# AMENDMENT OF SOLICITATION/MODIFICATION OF CONTRACT

1. The specifications and drawings for Invitation No. DACW64-02-B-0035, Placement Area Rehabilitation, House Tract, Houston Ship Channel, Texas, advertised 26 July 2002, and for which bids were postponed, are hereby modified as follows:

File 7850S  
**HOUSTON SHIP CHANNEL, TEXAS  
HOUSE TRACT  
PLACEMENT AREA REHABILITATION**

**INVITATION NO. DACW64-02-B-0035**

"TO BE ADDED TO DRAWING NO. 21."

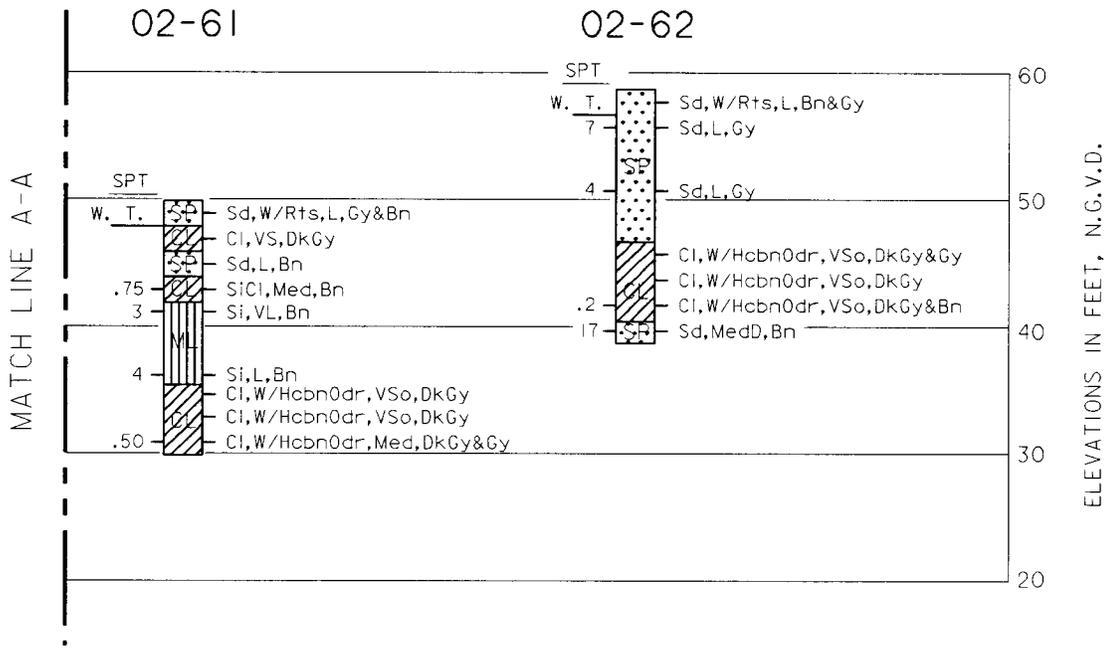
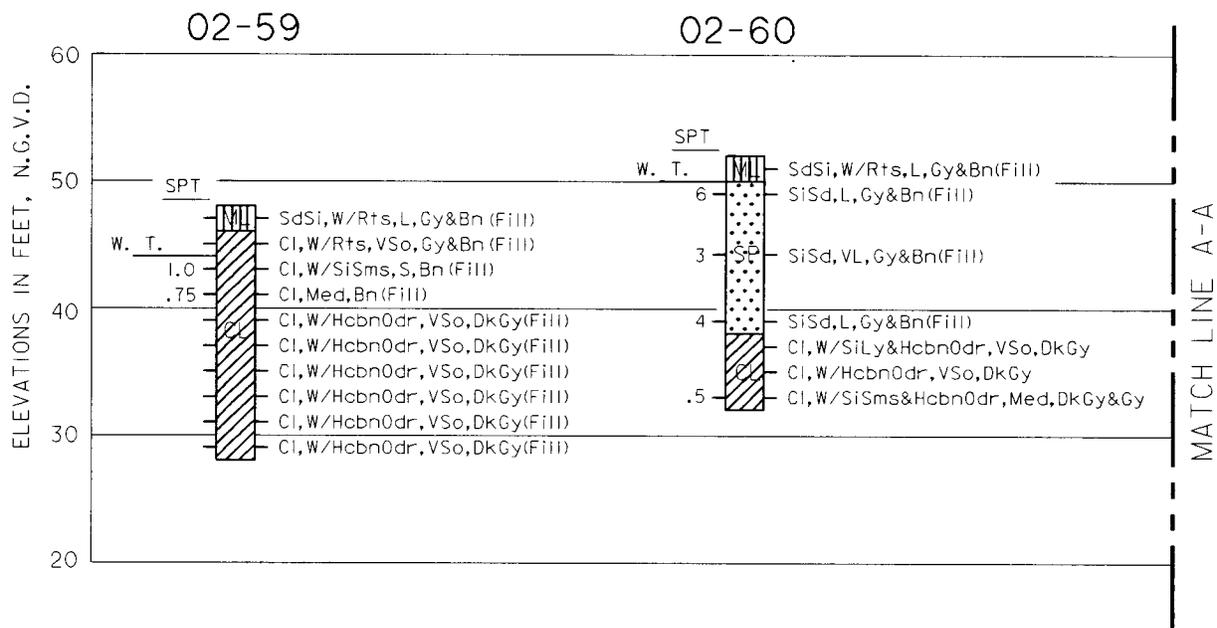
(13) Sheet 21 of 27. - Delete the BORING LOGS 87-48, 87-49, 87-50, and 87-51. The enclosed SKETCH NO. 1 shall be attached to this Sheet 21 of 27 and become a part of this Invitation.

"THIS SKETCH ACCOMPANIES  
 AMENDMENT NO. 0006 TO  
 INVITATION NO. DACW64-02-B-0035."
